INNER WEST

SUPPLEMENTARY REPORT

Application No.	MOD/2024/0085
Address	77 Glassop Street BALMAIN
Proposal	Section 4.56 Modification of Development Consent to DA/2022/0684 which approved demolition of existing structures and construction of residential flat building including basement parking and landscaping works, seeking consent for various internal and external modifications at all levels, including roof changes
Date of Lodgement	03 April 2024
Applicant	Chanine Design Pty Ltd
Owner	Ms Catherine Tuhetoka
Number of Submissions	Initial: 11 After Renotification: 6
Cost of works	\$3,288,563.00
Reason for determination at Planning Panel	Number of submissions exceed Officer delegations
Main Issues	Impact to Heritage Conservation Area; amenity impacts to adjoining properties, potential impact to trees on the rear adjoining property
Recommendation	Approved with Conditions
Attachment A	Recommended changes to conditions of consent
Attachment B	Original assessment report to November IWLPP

Figure 4: Extract of the most current Level 1 plan which relocates the pool structure outside the Tree Protection Zone.

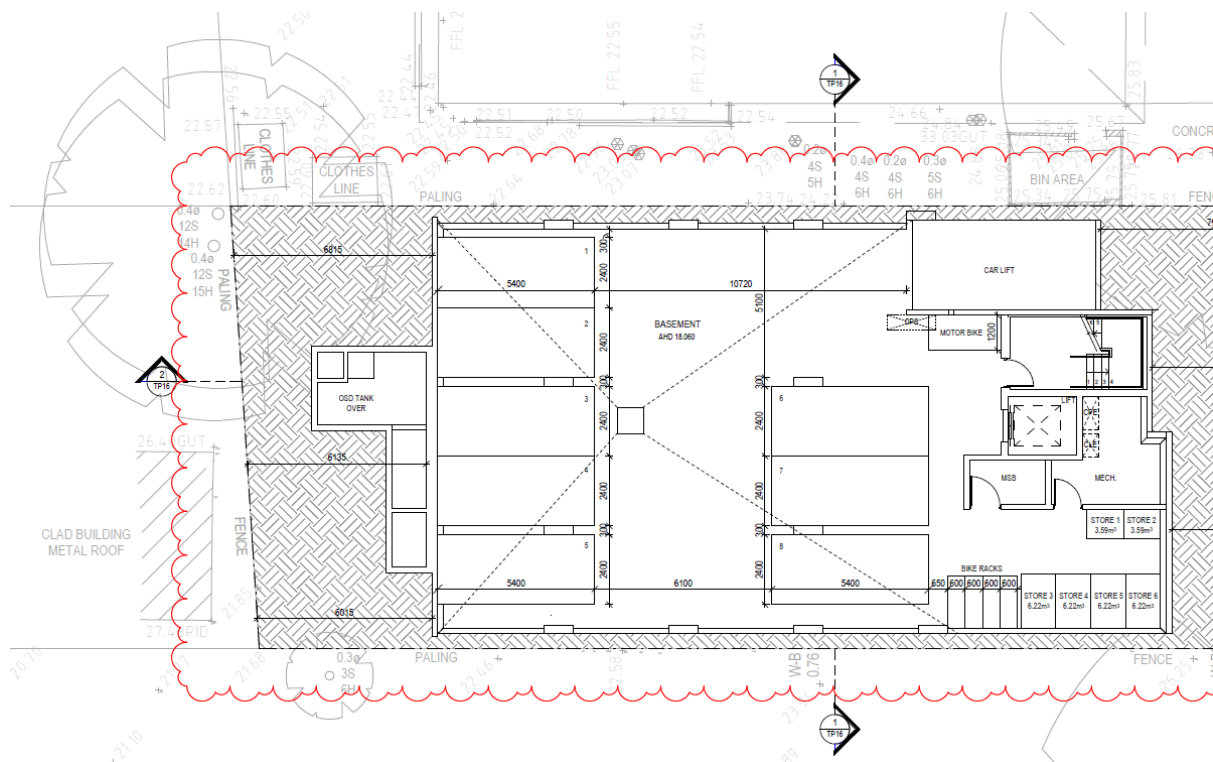
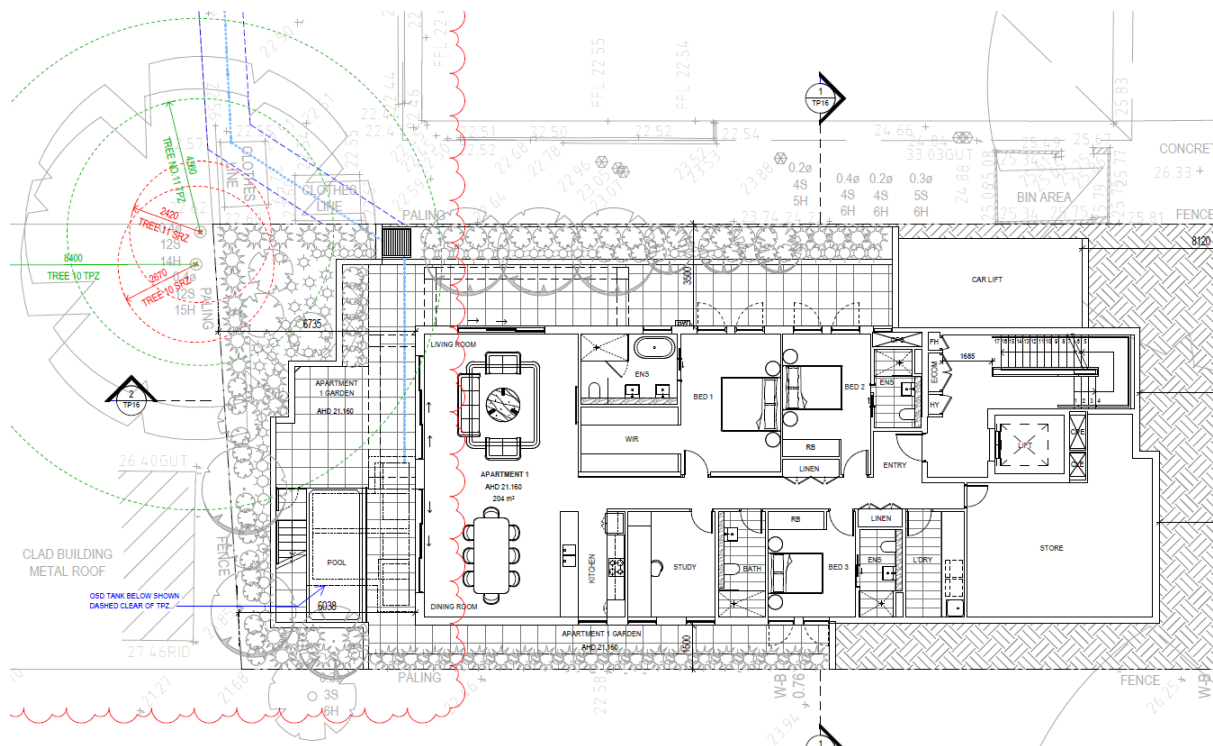
The applicant's arborist incorrectly assessed tree 10's TPZ and the original DA was assessed and approved using an incorrect and much smaller TPZ. The correct TPZ is 8.4m. The correct SRZ is 2.67m.

Comment: The applicant had amended the design (as mentioned above) so that the proposed OSD and swimming pool structure is located outside the Tree Protection Zone. The amended plans also demonstrate that the proposed stormwater system will be located outside the SRZ of the trees located at 2 Phoebe Street. The design has been reviewed by Council's Urban Forest team and the proposed retaining walls and landscaping is considered to be acceptable.

The amended design and the updated amended Arboricultural Impact Assessment has been reviewed by Council's Urban Forest team and is considered to be acceptable, the following conditions will be added and or amended:

- One additional condition has been added requiring all services to be located outside of any TPZ – see recommended Condition 35A in the Recommendation Section of this report.
- Condition 32 is to be amended to include a more rigorous inspection regime;
- The title of condition 33 should be amended to state: canopy pruning
- All TPZ measurements relating to Trees 10 and 11 have been updated to reference the said report; and
- Conditions referencing tree 11 as a *Ficus benjamina* have been updated to the correct species: *Brachychiton acerifolius*

Figure 5: The northeast elevation which faces 75 Glassop Street

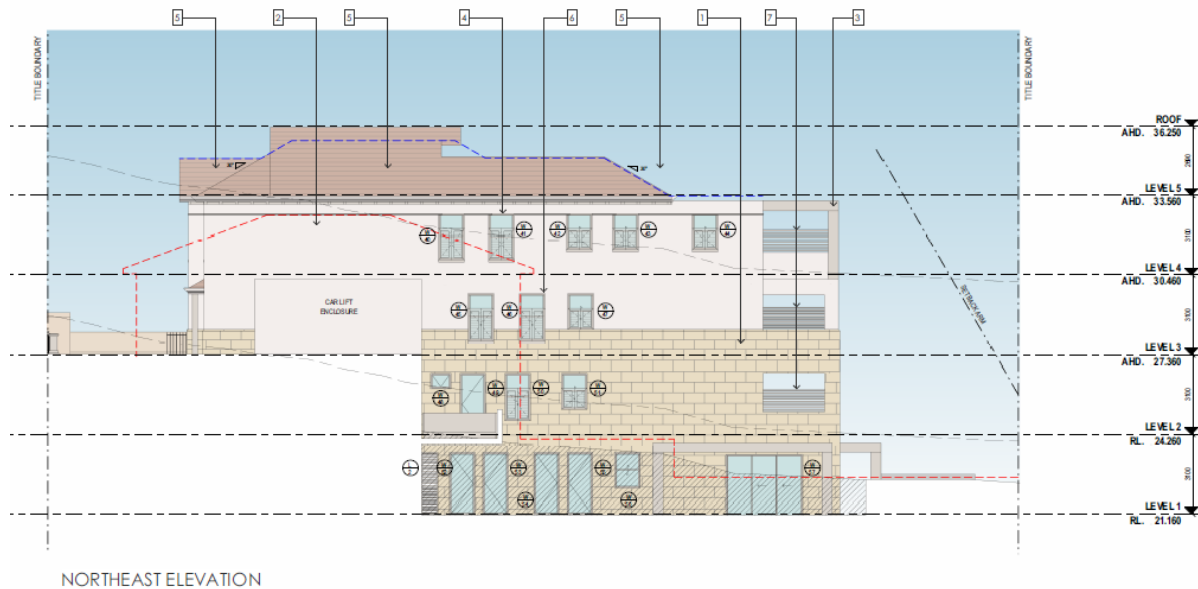
It is also acknowledged that the originally approved development did not require privacy mitigation measures to the side elevations, and the proposed modifications have included

shutters on the side elevations which result in a general improvement to the originally approved development with respect to visual privacy considerations. All the windows on the North-East elevation that faces 75 Glassop Street include shutters (and W58 is a highlight window).

Figure 6: The southwest elevation which faces 79 Glassop Street

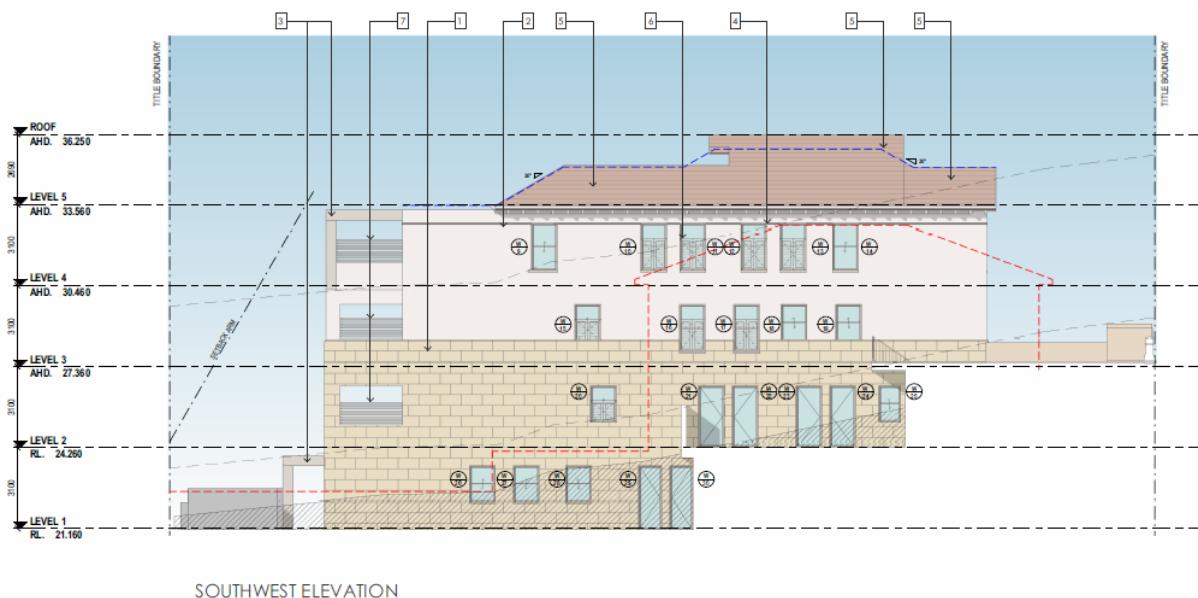
On the South-west elevations, the windows that does not include shutters (i.e. W9, W14, W18 and W19) are associated with a walk-in-wardrobe, ensuite, laundry and a powder/bathroom and therefore there are no adverse visual privacy impacts from these windows that does not provide shutters.

Figure 14 – View Analysis of 102A Glassop Street

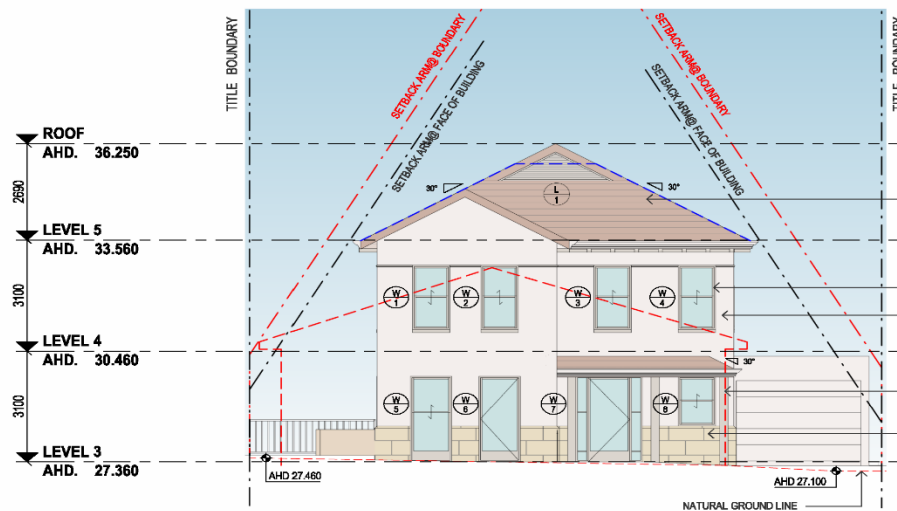
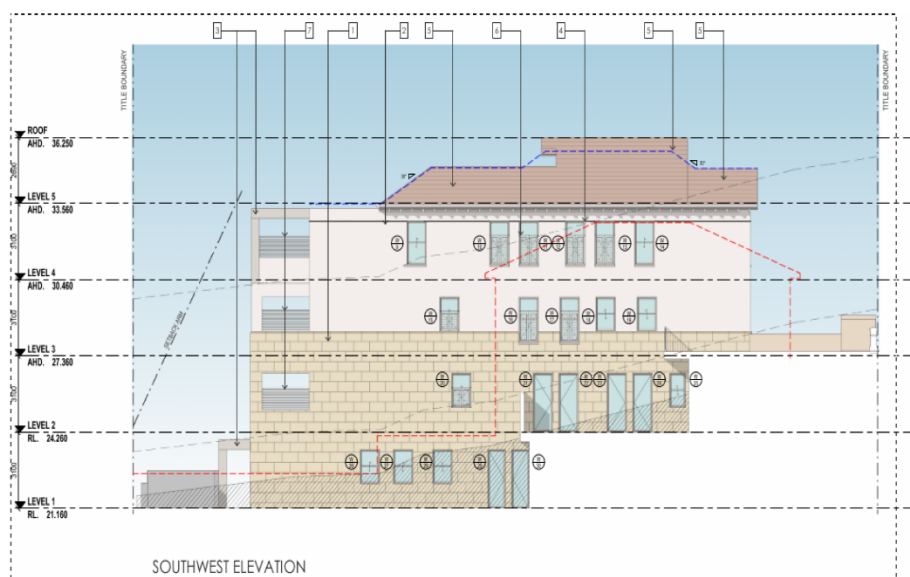
NOTE
VIEW TAKEN 1600mm ABOVE RL 33.00
FROM THE UPPER VERANDAH OF 102A
GLASSOP STREET, BALMAIN.
